Addendum

Subject: Addendum to **TH 7c**, Coastal Commission Permit Application
#A-6-LJS-07-114 (Mehl), for the Commission Meeting of 5/8/08

STAFF REPORT AND RECOMMENDATION ON APPEAL

Application No.: A-6-LJS-07-114

Fig 2

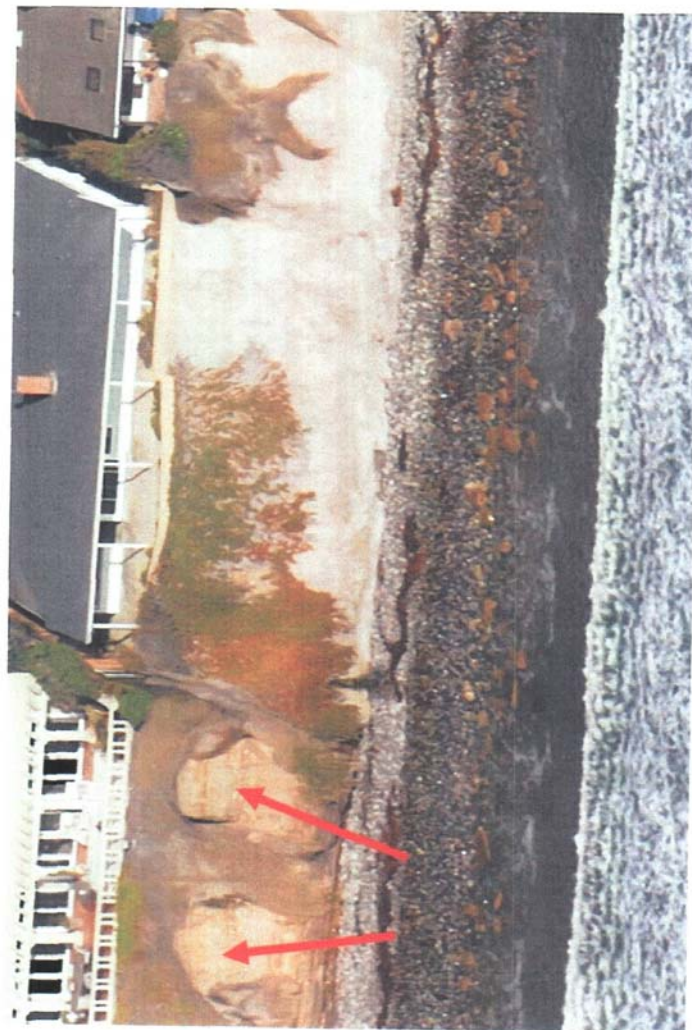
Many of the applicant's paid consultant's statements are incorrect. Evidence in the attached Figures 2 and 3 clearly shows visually erosion at both the northern and southern edges of the gunite section in question, but no change in the gunite section itself. In fact, the southern half of the applicants' property, the part NOT protected, shows severe undercutting. *The staff geologist for the CCC also states of the erosion control "it clearly is reducing the rate of bluff retreat, especially in the short term" (Mark Johnsson, email 24 April, 2008).* He goes on to state this situation will not hold in the long term (as the gunite crumbles). *Bottom line ...there is no evidence to substantiate the paid consultant's conjectures that the protection is ineffective.*

Cliff failure at house second to the north. The two scalloped areas red arrows) indicate the recent erosion and fact the failure mode is vertical, i.e. characteristic of rock cliffs

Fig 3

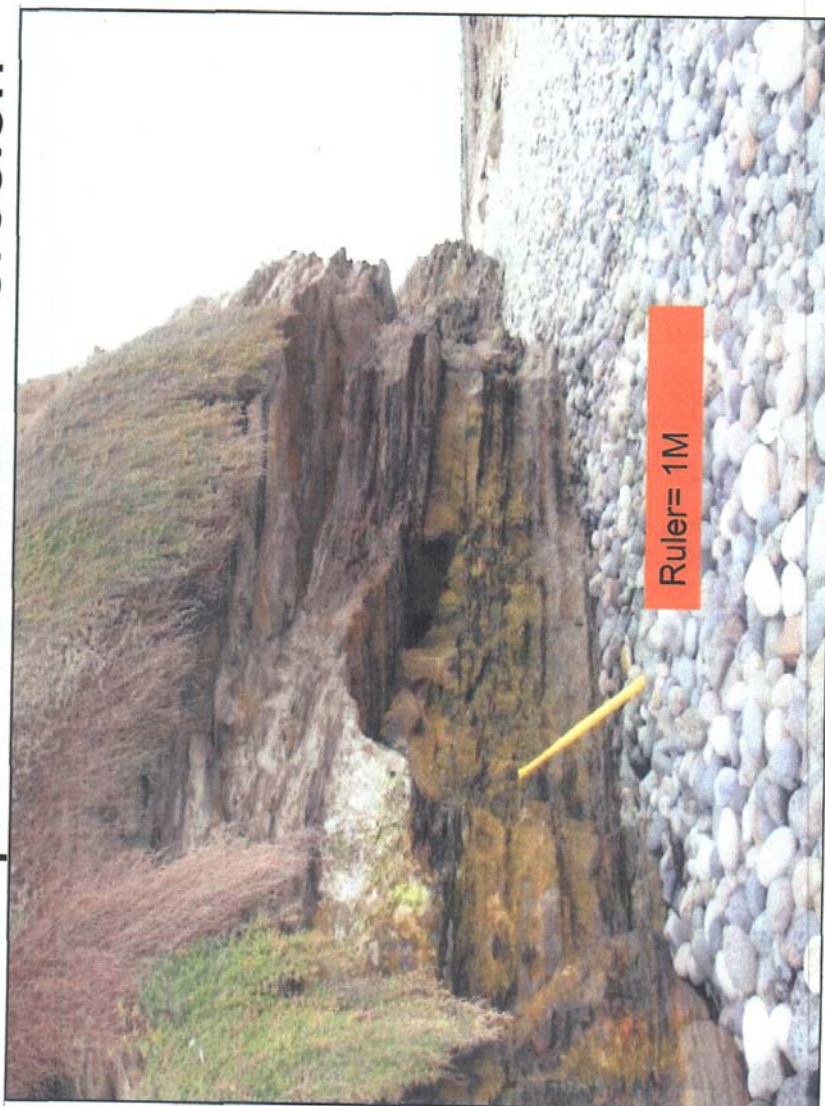
Bluff Undercut: Mehl south Unprotected bluff = erosion

Fig 6

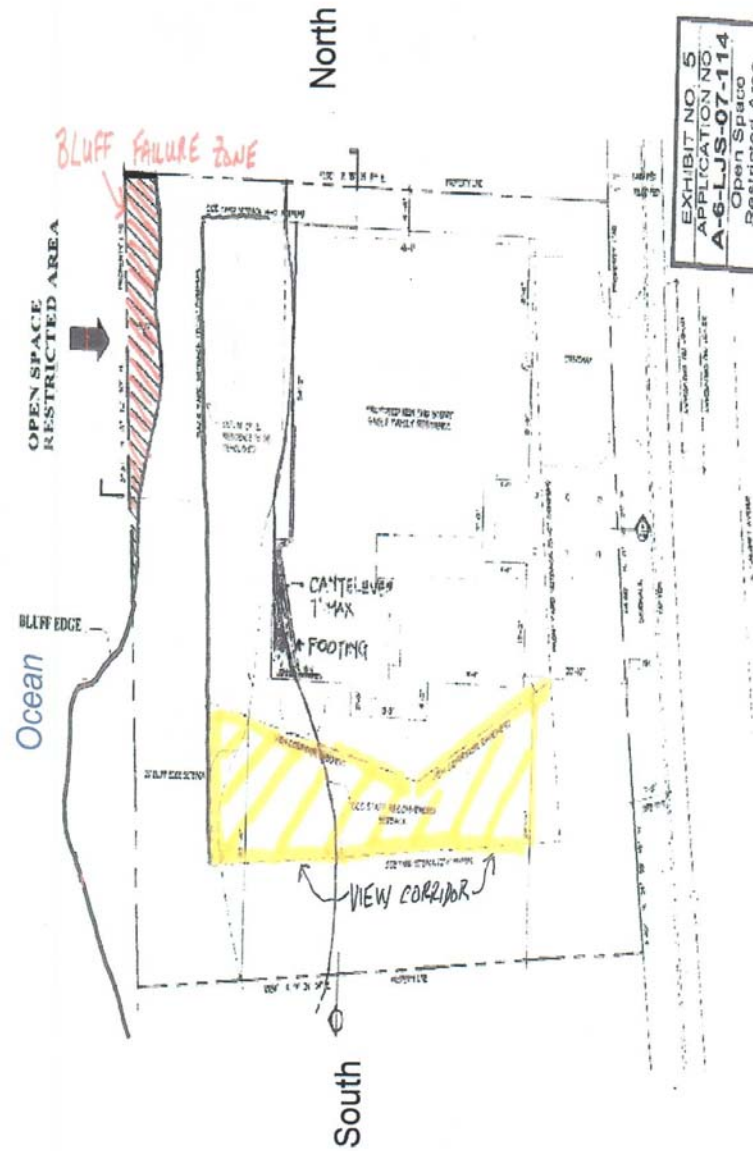
Further, the lot contains a view corridor at its southern end that is a deed restricted entity (Fig 6). The original Sungold Point developers allowed an extra 20 feet onto this lot in order to make up for land used in the view corridor. This land can never be built on.

Unbuildable Space (colored)

EXHIBIT NO. 2
APPLICATION NO.
A-6-LJS-07-114
Detailed site plan
w/recommended
geologic setbacks

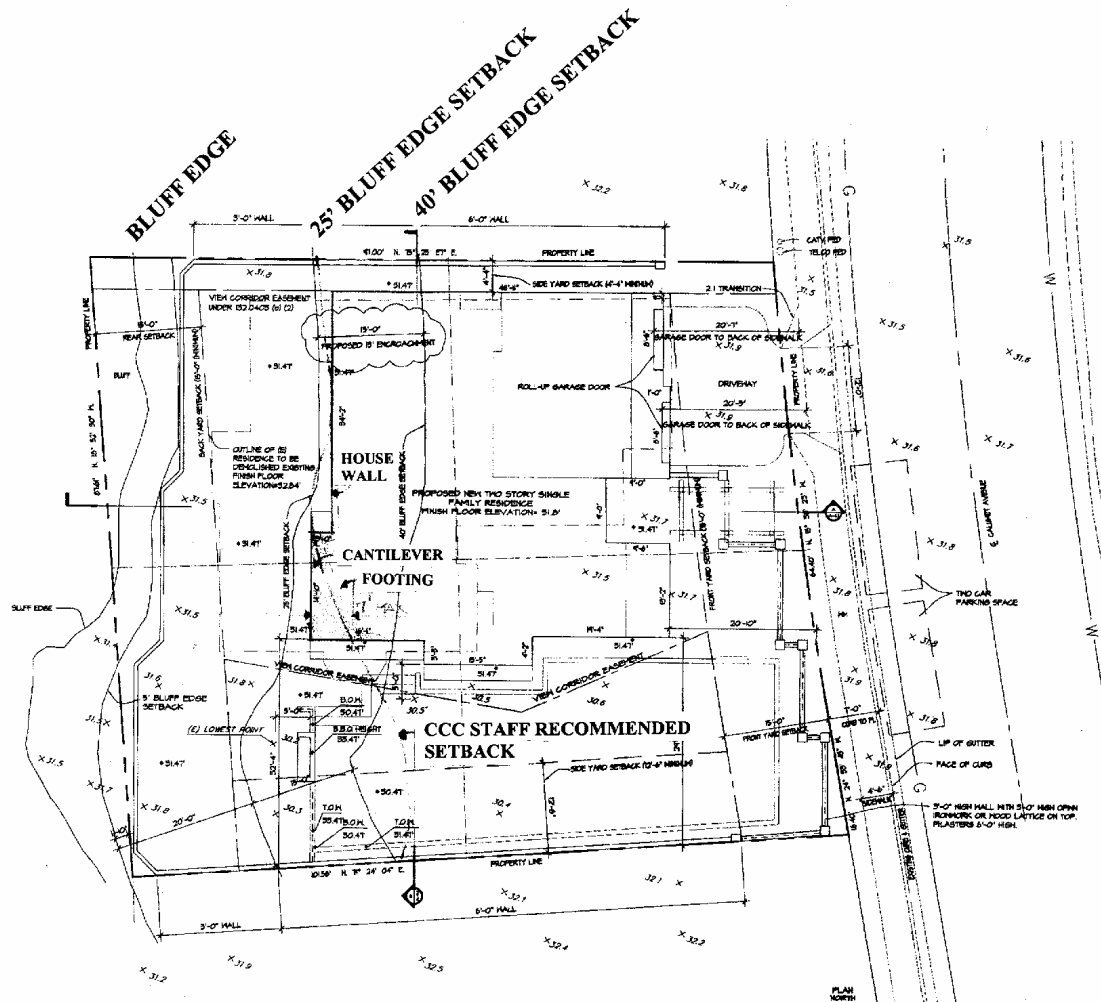
- c. All existing and proposed accessory improvements shall be identified. All accessory improvements (including, but not limited to, patios, decks, walkways, and open shade structures) proposed within the geologic setback area must be "at-grade" and located no closer than 5 ft. from the edge of the existing bluff, as shown in concept, on Exhibit No. 2.

EXHIBIT NO. 3

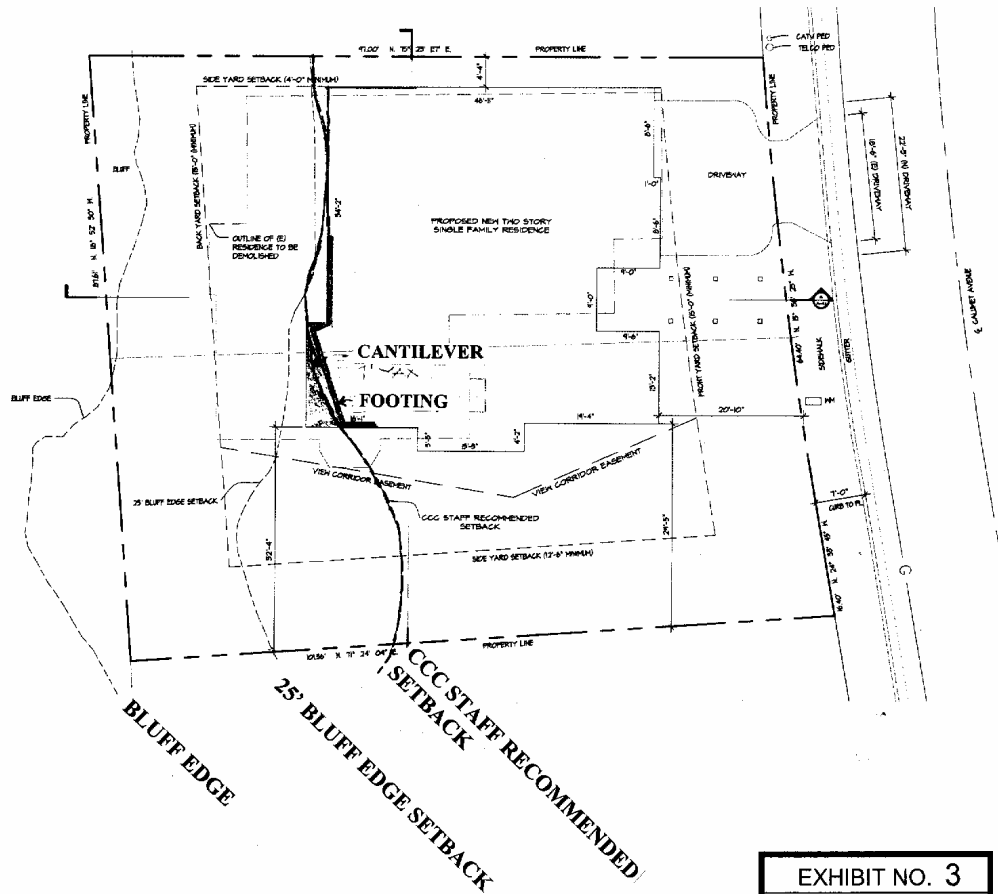
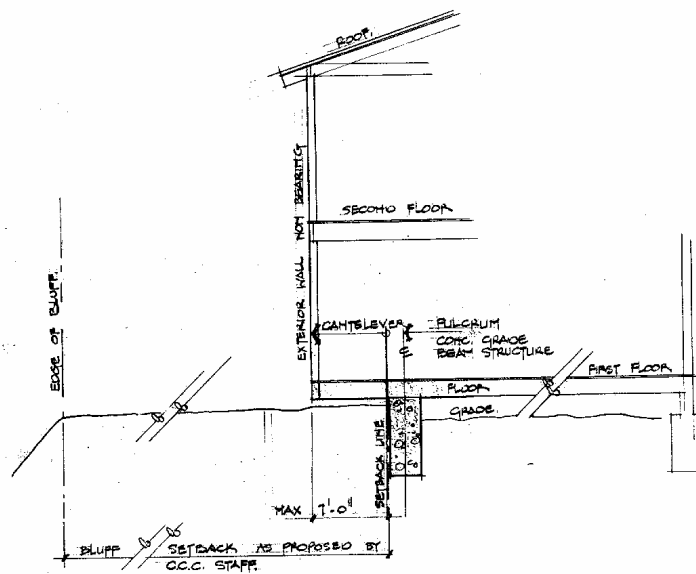
- a. The proposed residential structure will be set back a minimum of approximately 25 ft. from the bluff edge on the subject site, as shown in concept, in Exhibit No. 3.

- b. Foundation plans, including structural calculations, that document that the southwest portion of the proposed structure will be cantilevered a distance of one ft. to a maximum 7 ft. seaward of the geologic setback line, as shown in concept, in Exhibit Nos. 3 & 4.

In response to the concerns raised by the Commission's staff geologist, the applicant has revised his project to incorporate the use of a small cantilever in the southwest portion of the home. Specifically, the applicant has indicated that they can design the home such that all of the load bearing and foundation systems would be located landward of the Commission geologist's recommended setback line (ref. Exhibit 4 attached). The cantilevered portion of the home would be a very small triangular-shaped portion of the lot in the southwestern portion which ranges from about one foot to a maximum of 7 ft. This coincides with the only portion of the building footprint that was proposed to be located seaward of the Commission staff recommended setback line. The Commission's geologist has reviewed the applicant's cantilever design foundation proposal and concurs that it is acceptable from a geologic standpoint.
